## 800S – MEAT TABLE / PLASTIC GUARD

ID / Issue: **10350-1**

Systems affected: 800S

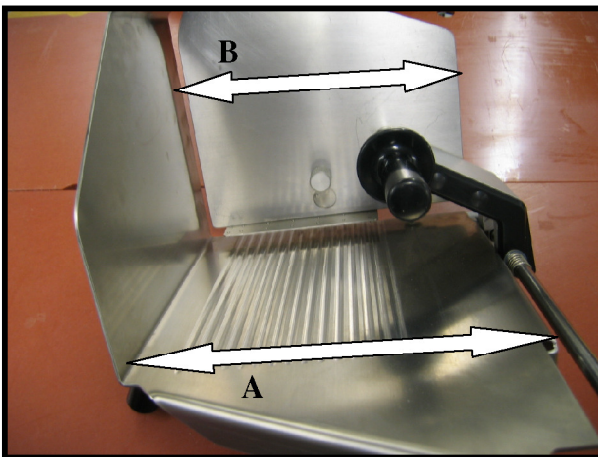
For reasons of hygiene the 800S Perspex Guard (3801-3397) is no longer available. As you will also be aware (from SIC 766) the narrow version of the 800S stainless meat table (4601-3908) is also no longer available. As a result only the wide version of the 800S meat table (4601-3899) is available.

If you have to replace a narrow table with the new wider version it is mandatory that you replace the pusher plate assembly. Please see photo and table below:

TABLE / PUSHER PLATE DIMENSIONS	'A' (mm)	'B' (mm)
Narrow version	240	230
Wide version	262	252

Part Number	Description
4601-3899	Wide stainless steel meat table
4601-3853	Wide pusher plate complete assembly
